-----  
ADDRESS . : 2546 BYRDS MILL RD  
CONTRACTOR :  
OWNER . . : MATTHEWS DEMETRIC S & BERDINA  
PARCEL . . : 12-0576- - -0022- -25-  
APPL NUMBER: 08-50019471 CP NEW RESIDENTIAL (SFD)  
DIRECTIONS : 157 GREENCREST DRIVE LINDEN 28356.  
COWAN SUB DIV SEC II LOT#10. GO DOWN  
401S TOWARDS FYETTEVEILLE, GO THROGH  
THE TOWN OF BUNNLEVEL, COME TO  
PLANTATION ON THE LEFT, BARE TO THE  
LEFT AT THE PLANTATION HOUSE, THAT IS  
BYRDS MILL RD, MY LOT IS THE LAST LOT  
ACROSS FROM LAST TWO SWMH ON THE LEFT.  
T/S: 02/21/2008 08:14 AM VBROWN -----

-----  
**STRUCTURE: 000 000 73X53'6.5" 4BDR 3.5BATH SFD**

Steve Tuma  
Landmark Home & Land  
Re: Matthews Residence, North Carolina

MATTHEWS Residence Framing Issues:

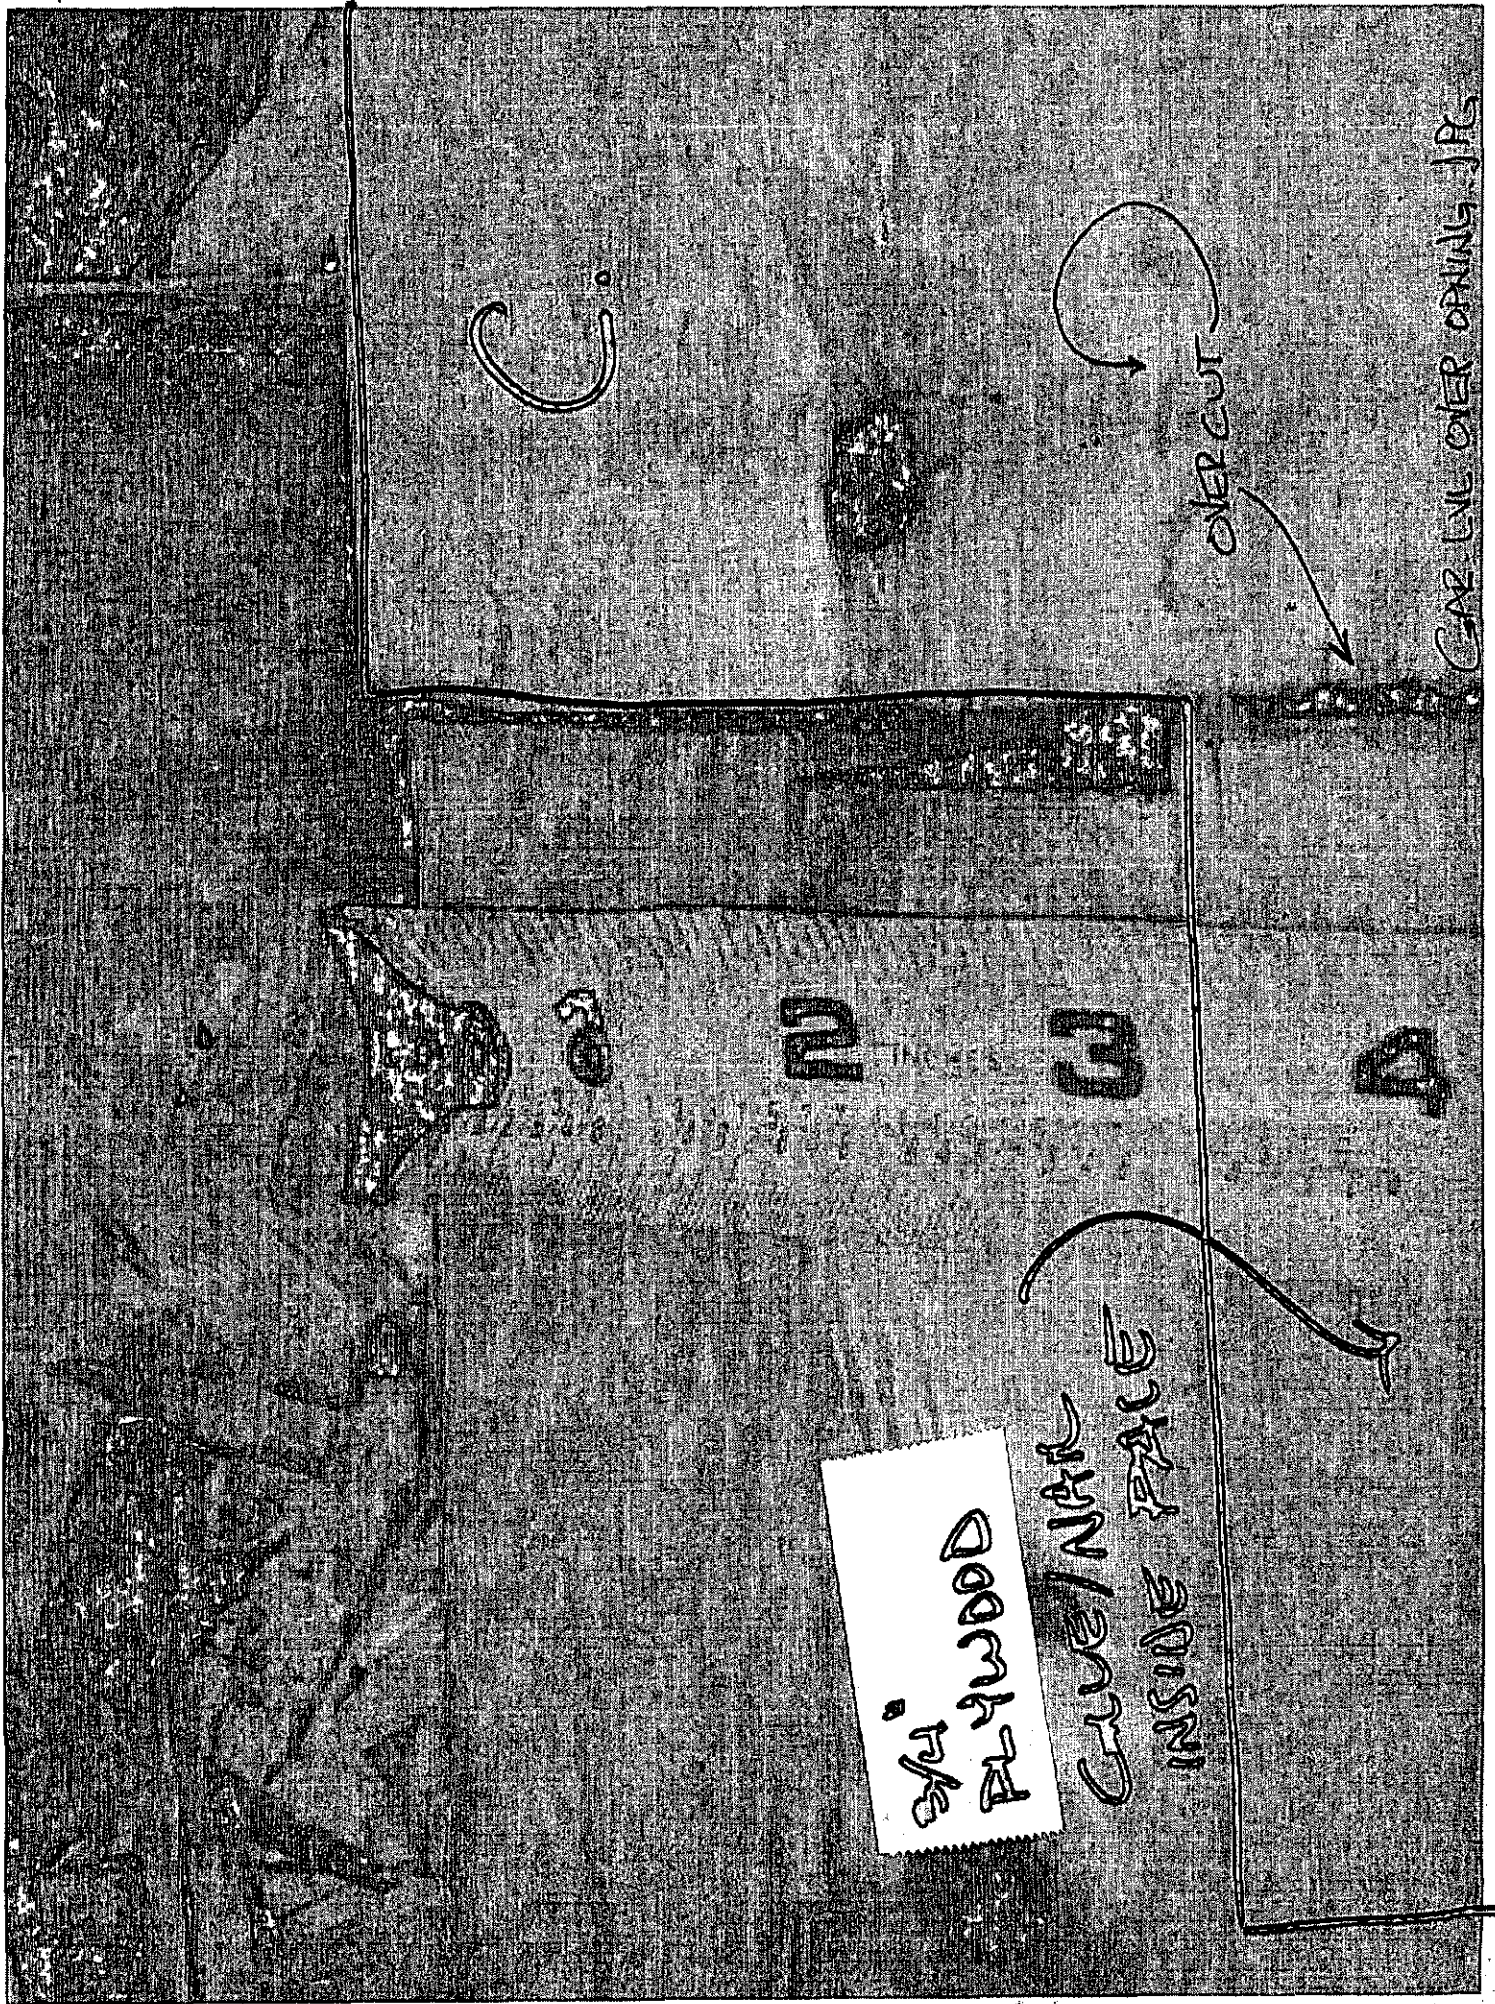
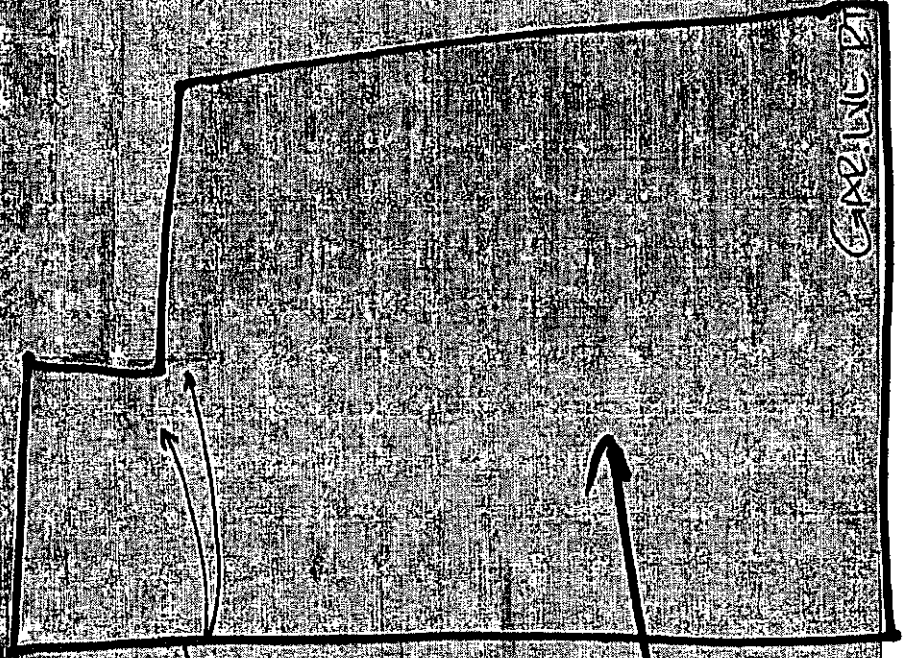
I have reviewed the pictures sent to us by Mr. Matthews in regards to his framing. Most of the LVL beams he has documented are OK with no modifications being made. I am including a layout of the first floor of the house with beam bearing conditions marked A-D. Corresponding pictures from Mr. Matthews are also included. These notches require attention only because of the amount of overcut done by the framer. The method of repair is as follows:

Also, in reviewing the stresses on these beams, it was noticed that the beam that crosses the kitchen is undersized. To correct this:

Use solid pieces of  $\frac{3}{4}$ " PLYWOOD to attach to the side of the LVL beam. A, C, and D will be repaired on only one side. B will be repaired on both sides. Use plywood that is the same depth as the beam and 16" wide. CLEANLY cut the notch required. Use subfloor adhesive and 10d nails @ 2" o.c. at edges and entire face of plywood to attach plywood to the face of the beam.

A 16" LVL [total of (2) 16" LVL] will need attached to both sides of the existing beam, which is (2) 11-7/8" LVL. The existing beam should already be nailed together. The new 16" LVL should be nailed to the face of the existing beam (flush at the top) using 2 rows of 16D nails @ 6" o.c. There should be 1 row 2" from the top and 1 row 2" from the bottom of the 11-7/8" beam. The beam pocket closest to the garage will need expanded to fit the new plies. On the Great Room end, the new plies will need to be cleanly notched to sit on top of the LVL beam at the opening of the Great Room. I've drawn a schematic detail of this beam assembly on the included layout.

Job: (E070) Mathews roof / 66 gussets.

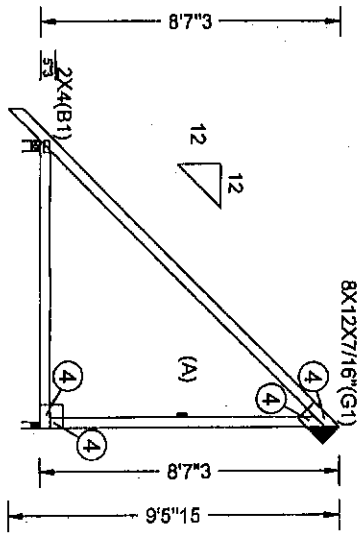
1. A shop drawing is included for the truss 66 that has had its vertical web ripped to 2" wide. OSB gusset plates will need to be installed to account for metal truss plates that have been compromised. (See specs on the shop drawing.) The wall that supports trusses 55-56 should have had a 2<sup>nd</sup> top plate installed on site. In the absence of a 2<sup>nd</sup> top plate, solid blocking shall be installed between top plate and each truss. Furthermore, a stud will need to be added in the wall beneath each roof truss that is not bearing on 2 continuous top plates. OSB gusset plates will need to be installed to account for metal truss plates that have been compromised.

(G1) Gusset Plates are 7/16" APA RATED OSB SHEATHING, 24/16, EXP 1.  
 Apply gusset to each face of truss and attach with evenly distributed 6d Box (0.099x2.0") Nails specified in circles. Hatched lines indicate portions on gussets protruding outside of the perimeter of the truss that may be trimmed flush with the truss profile.  
 Minimum Nail/Screw Spacing Requirements Based on ANSIA/A-FAPA NDS-2001:  
 End Distance 1-1/2" Edge Distance 1/2"  
 Spacing Between Rows 1/2" Spacing in a Row 1-1/2"  
 Maximum Number of Rows for Member Size:  
 2x4 5 Rows

The vertical web of this truss is still structurally sufficient when ripped to only 2" wide.  
 Note the gusset specifications above that must be installed due to truss plates that have been reduced on site.
